**ADVICE IN RELATION TO THE POTENTIAL
IMPACTS OF COAL SEAM GAS EXTRACTION
IN THE SURAT AND BOWEN BASINS,
QUEENSLAND**

Phase One Final Report

**AUSTRALIAN GOVERNMENT
DEPARTMENT OF THE ENVIRONMENT,
WATER, HERITAGE AND THE ARTS**

Geoscience Australia and Dr M.A. Habermehl

Figure 2.1-2. Location of natural groundwater discharge sites (springs) with respect to coal seam gas tenements considered in the current assessment.

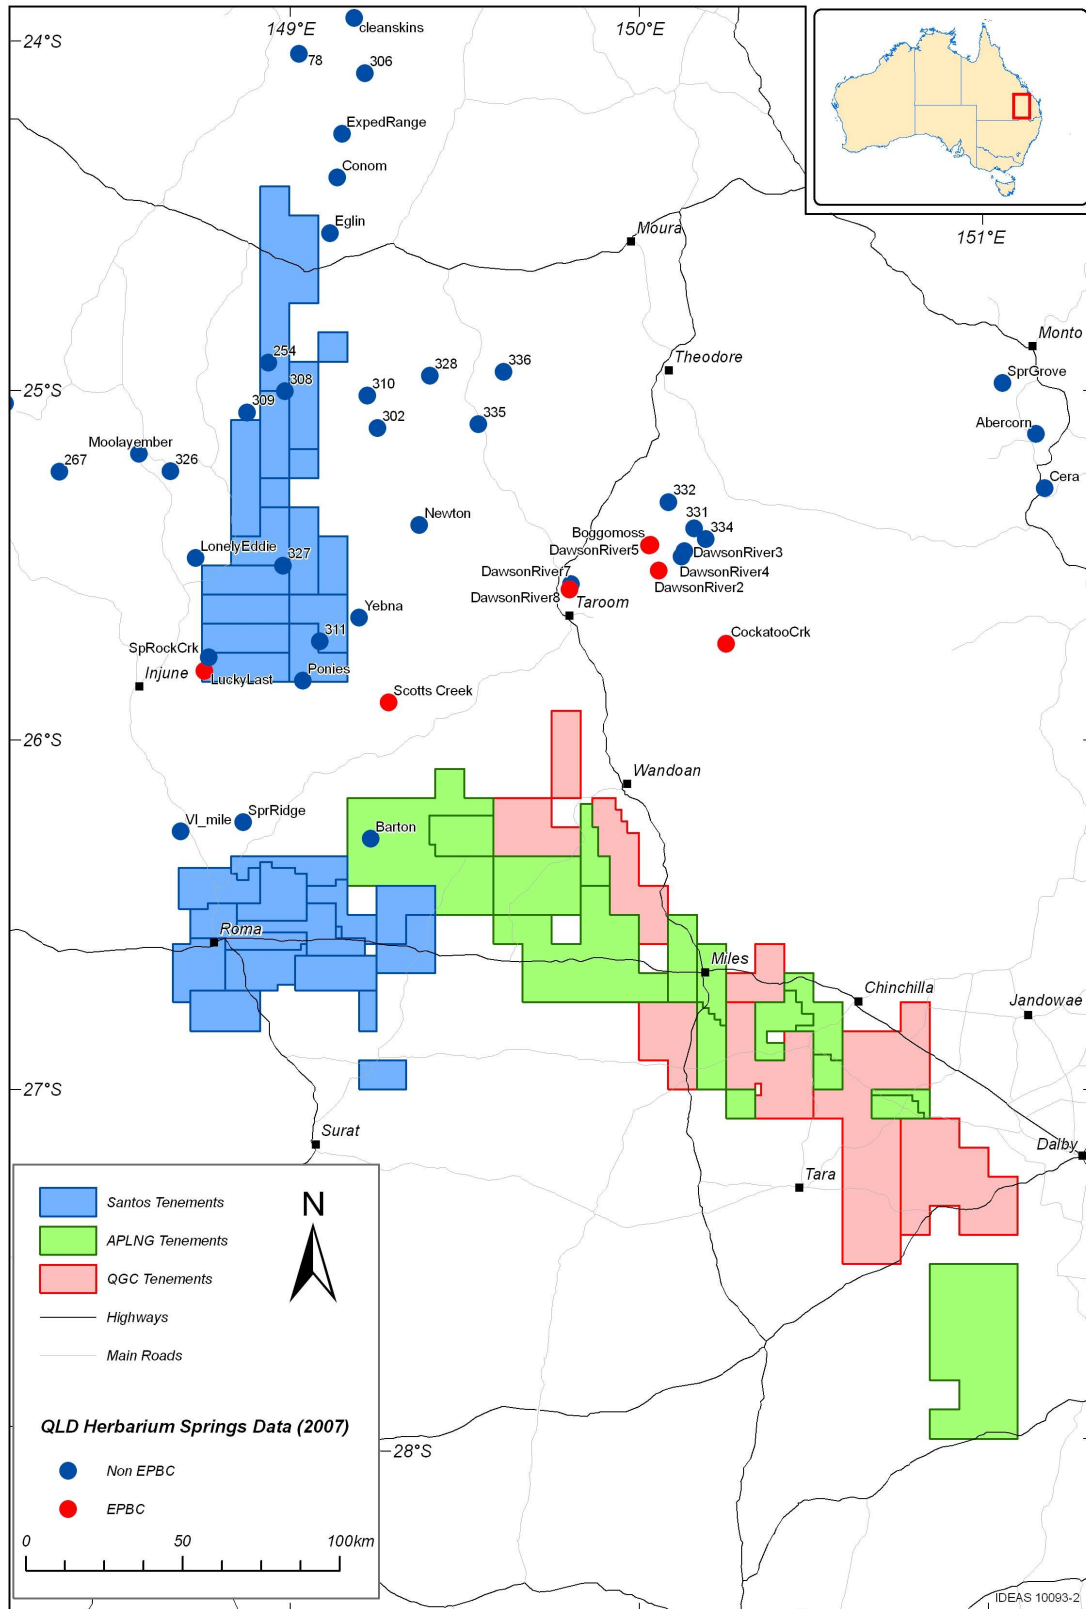
Only one registered “recharge” spring was identified within APLNG leases, in the western corner of the Pine Hills development area (Fig. 2.1-2). The spring is included on the Qld GAB WRP Springs Register and the Qld Herbarium database, but does not appear in the DEWHA mapping of Threatened Ecological Community - The Community of Native Species Dependent on Natural Discharge of Groundwater from the Great Artesian Basins. The spring is listed as ‘RJF Site No NV333’ and classified as active but not visited. APLNG hydrogeologists visited the site in July 2010 and reported no surface hydrological expression or vegetation indicative of a spring or GDE. The feature was reported as a possible seepage relating to an incised erosional feature at base of deep soil profile after significant rainfall (APLNG response to Geoscience Australia questions – 23 August 2010, p. 29).

APLNG identify numerous high value “recharge” and “discharge” spring complexes associated with the Hutton Sandstone and Precipice Sandstone units. These are located proximal to the Taroom and Injune townships, at least 50 km north and north-west of the northernmost APLNG development areas (DNR 2005). The “discharge” spring complexes located near Taroom are supplied by artesian flow from the Precipice Sandstone, rising to the surface through joints and fractures in that unit. These complexes are known locally as 'boggomosses', and provide a wetland habitat in an area that experiences prolonged below average rainfall conditions (DEWHA 2001) (APLNG Vol. 2, Ch. 10, p. 17).

Figure 2.2-2. Location of natural groundwater discharge sites (springs) with respect to coal seam gas tenements considered in the current assessment.

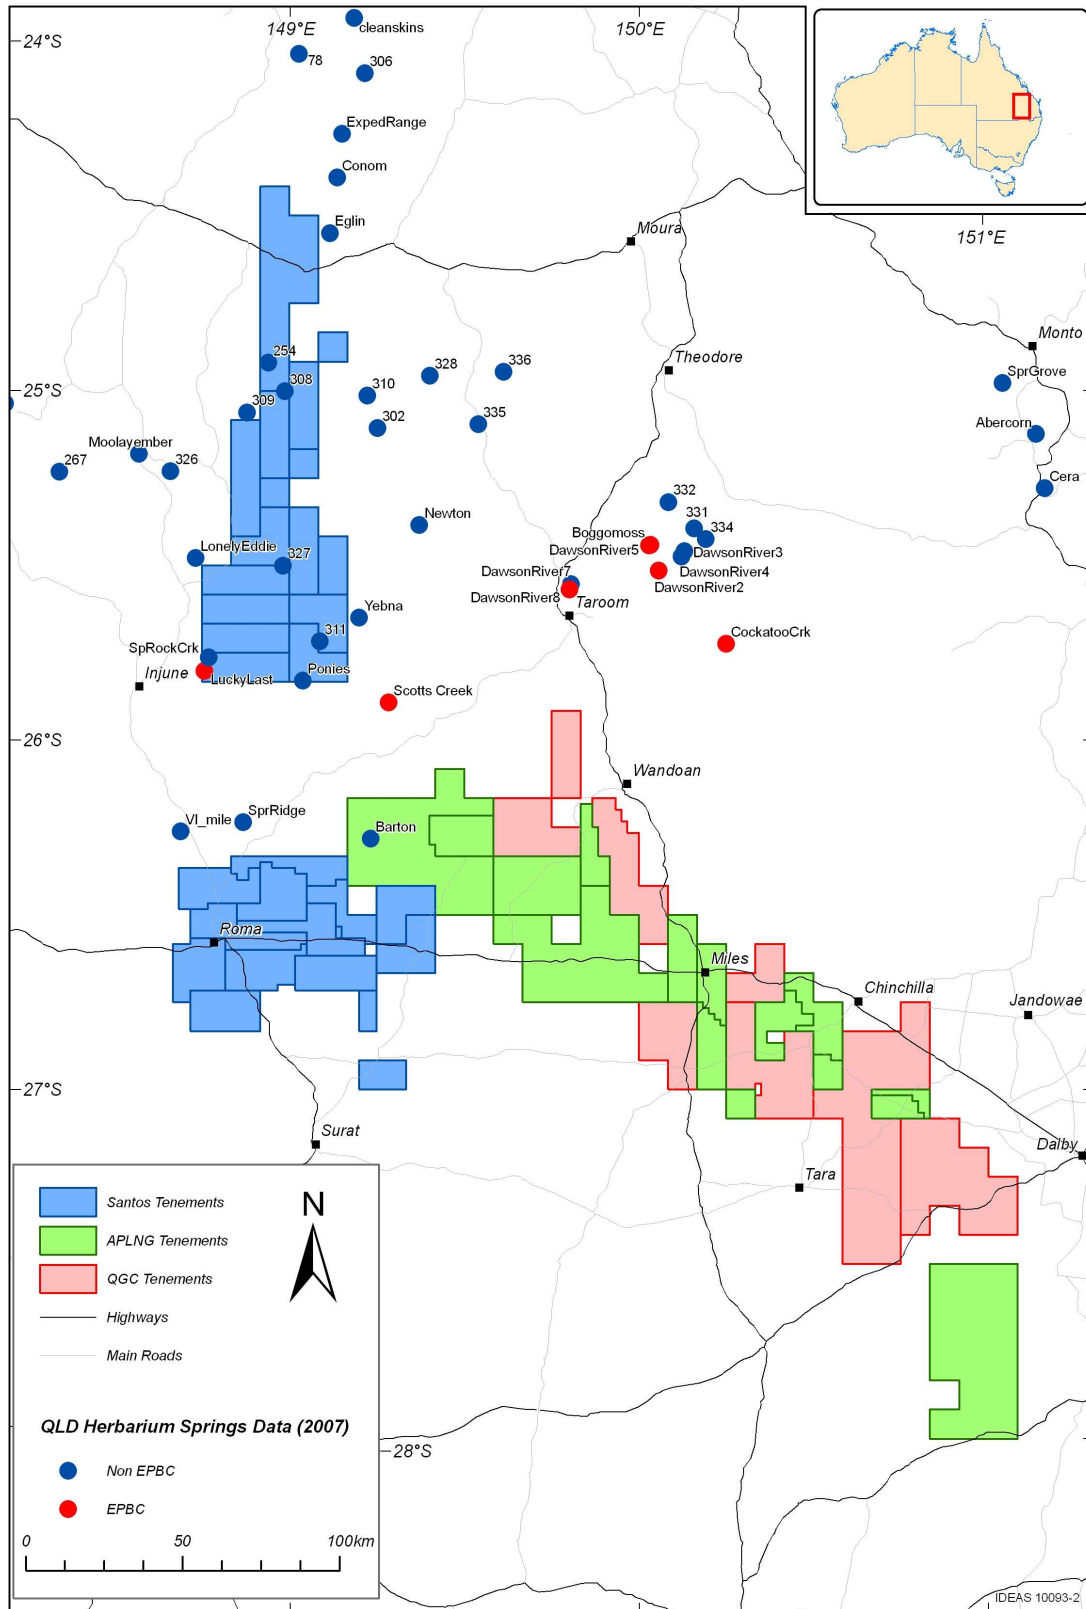
QGC provide little information in their main EIS documents regarding the assessment, monitoring and mitigation of potential impacts of groundwater extraction on the EPBC Act listed endangered ecological community 'The community of native species dependent on natural discharge of groundwater from the Great Artesian Basin'. Initial assessment of an insignificant impact is the stated reason for this information not being considered in their final reporting (QGC Response to Geoscience Australia initial Assessment – 13 August 2010, p. 10), owing largely to the absence of any listed springs within or in close proximity to their tenements. Based on a review of the Queensland Herbarium Springs of Queensland Dataset (Version 4.0), QGC identify and report that no "discharge" springs or EPBC Act threatened communities of 'native species dependent on the Great Artesian Basin' occur within the study area (QGC Vol. 3, Ch. 8, p. 5).

GA and Dr M.A. Habermehl also identify no EPBC listed communities within the QGC tenements or within the QGC modelled zone of depressurisation. Some springs (type unspecified) are noted by QGC within 30 to 50 km of the CSG project area. At 30 to 50 km from the CSG fields QGC predict that drawdown in the Springbok Sandstone aquifer (Injune Creek Group), Hutton Sandstone and Precipice Sandstone aquifers will be negligible (QGC App. 3.4, Rep. 7, p. 72).

Figure 2.2-3. Location of QGC tenements shown relative to the defined areas of the GAB intake beds used for annual recharge calculations.

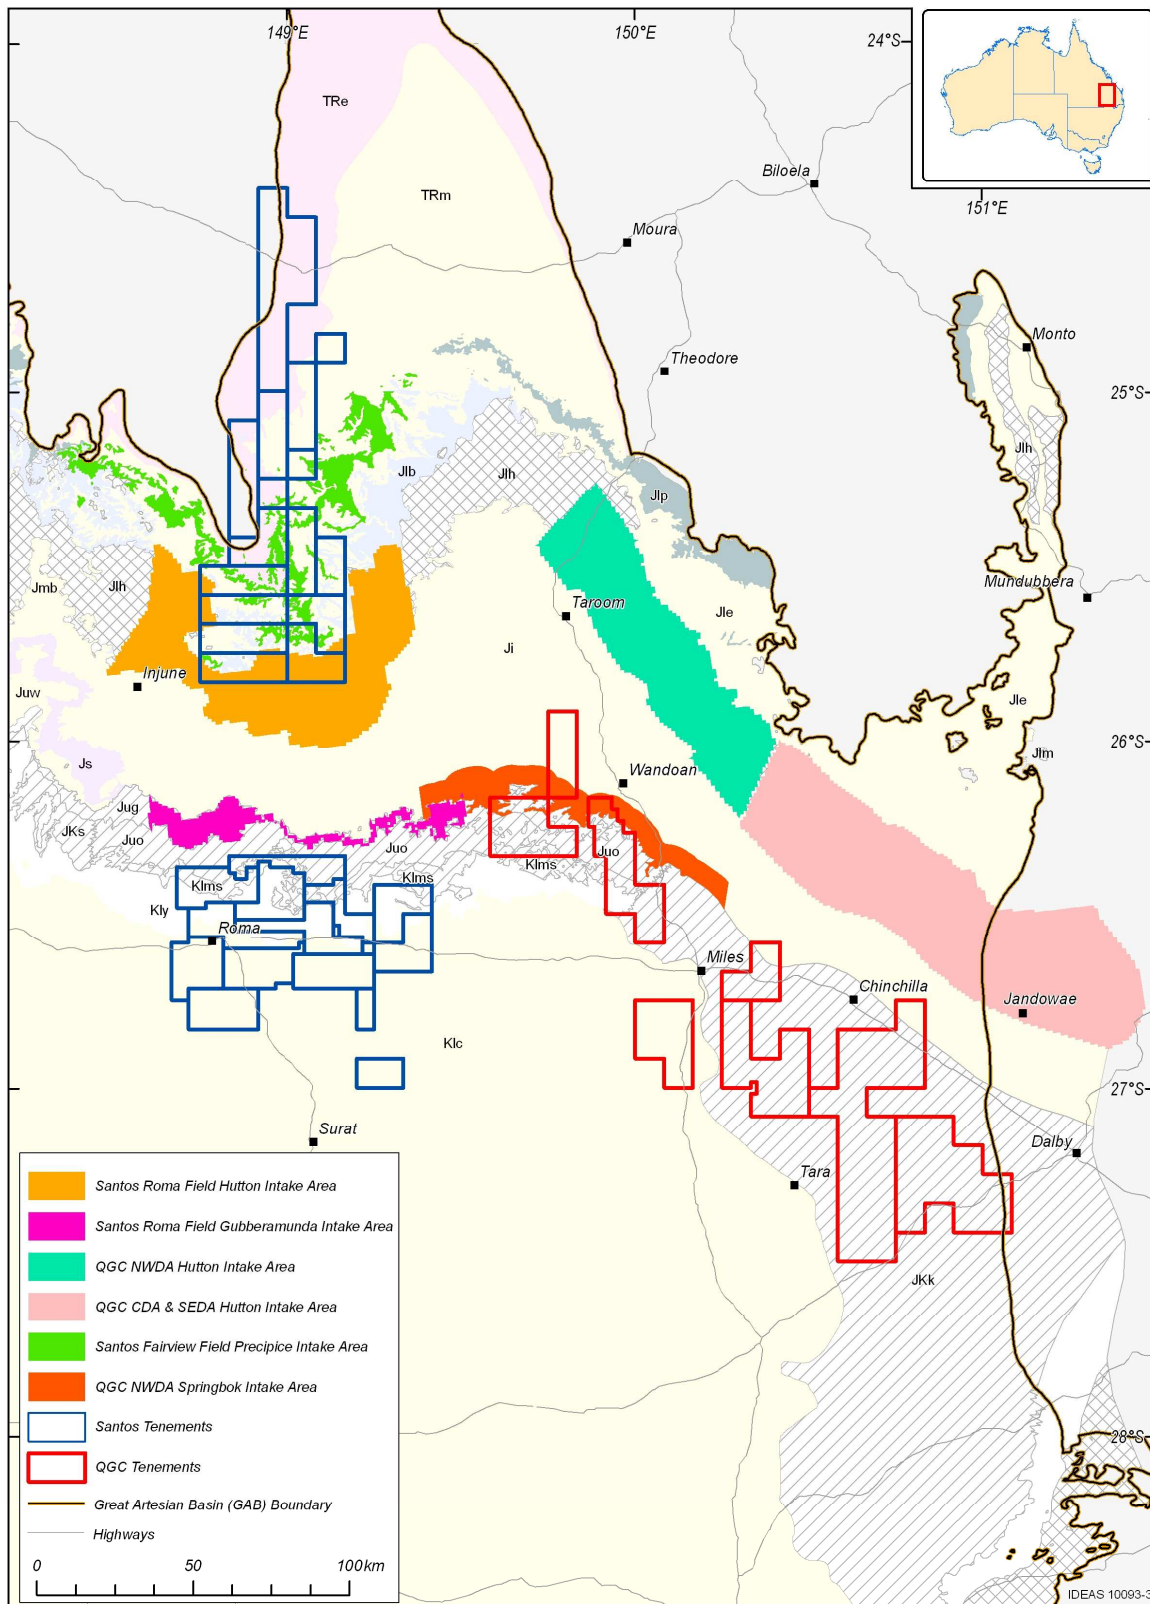
In contrast the “Groundwater Monitoring Strategy Risk Assessment Matrix” in the EIS indicates that the probability of “Loss of available water/loss of water column in bores” (i.e. drawdown caused by the extraction of associated water) within bores tapping the “Precipice & Hutton” and the “Springbok & WCM” is high, but that the risk of “Reduction in through flow to down-gradient aquifers” is low.

It is the opinion of GA and Dr M.A. Habermehl that the risk of reduction in through-flow to down-gradient aquifers is highly likely to occur but the magnitude of the reduction will only be known after production commences and monitoring information becomes available. Modelled drawdowns should be compared with the monitoring results and the numerical model adjusted and re-run with updated information. Based on the current analysis, however, the magnitude of the impact on GAB water balances is likely to be low.

Figure 2.3-2. Location of natural groundwater discharge sites (springs) with respect to coal seam gas tenements considered in the current assessment.

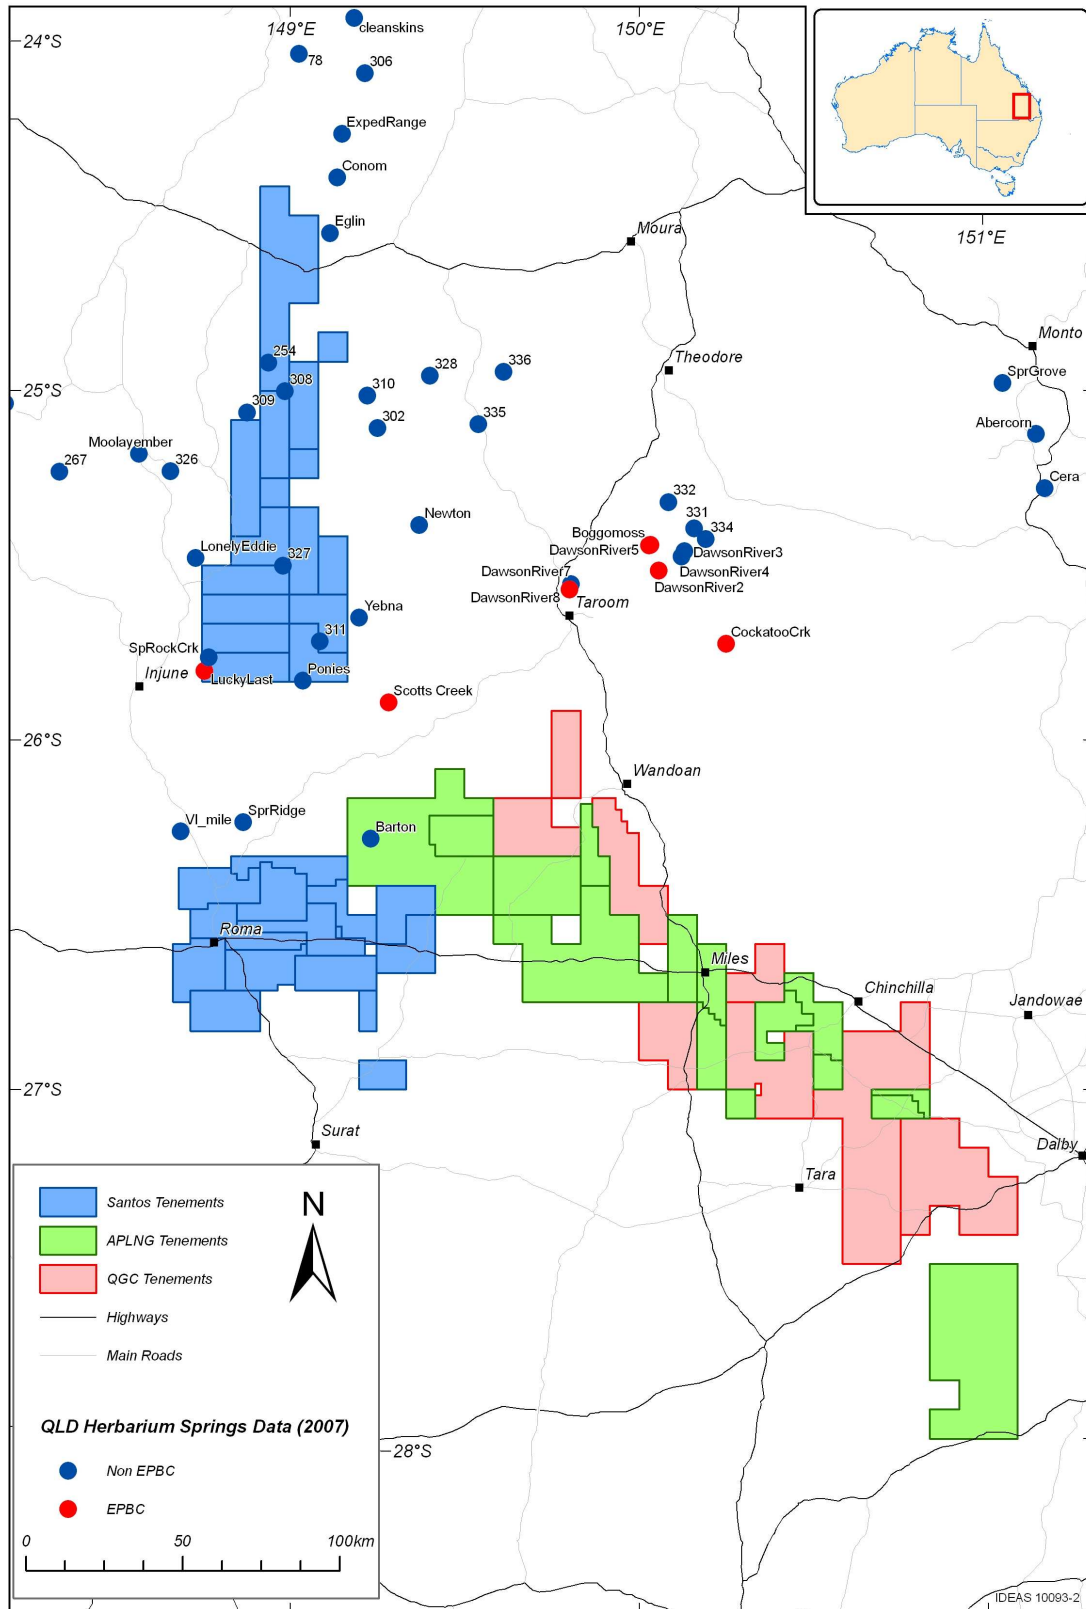
Dry season field investigations (Santos Appendix N4) identify no rare or threatened aquatic species at active artesian spring sites in catchments adjacent to and containing the Santos CSG fields. In the Upper Dawson catchment the endangered (and EPBC Act listed) macrophyte salt pipewort (*Eriocaulon carsonii*) has been recorded at the Hutton Spring Group on Hutton Creek (Fensham and Fairfax 2004), and the consultant's report suggests that artesian springs elsewhere in the CSG fields may support similar communities, where comparable geomorphic and hydraulic conditions are present. Furthermore the consultant identifies the likely presence of the EPBC critically endangered Boggomoss Snail (*Adclarkia dawsonensis*) in one of the Santos leases to the west of Taroom, but not in any of the Fairview, Arcadia or Roma tenements.

The Taroom 1:250,000 Geological Map Sheet Explanatory Notes (Forbes et al. 1967) report that "The mound springs in the Hutton Creek area, north-east of Injune, are probably supplied by artesian water from the Precipice Sandstone, which rises to the surface through joints or small faults." If the latter is correct, then these springs are "discharge" springs, and should be considered under the EPBC Act.
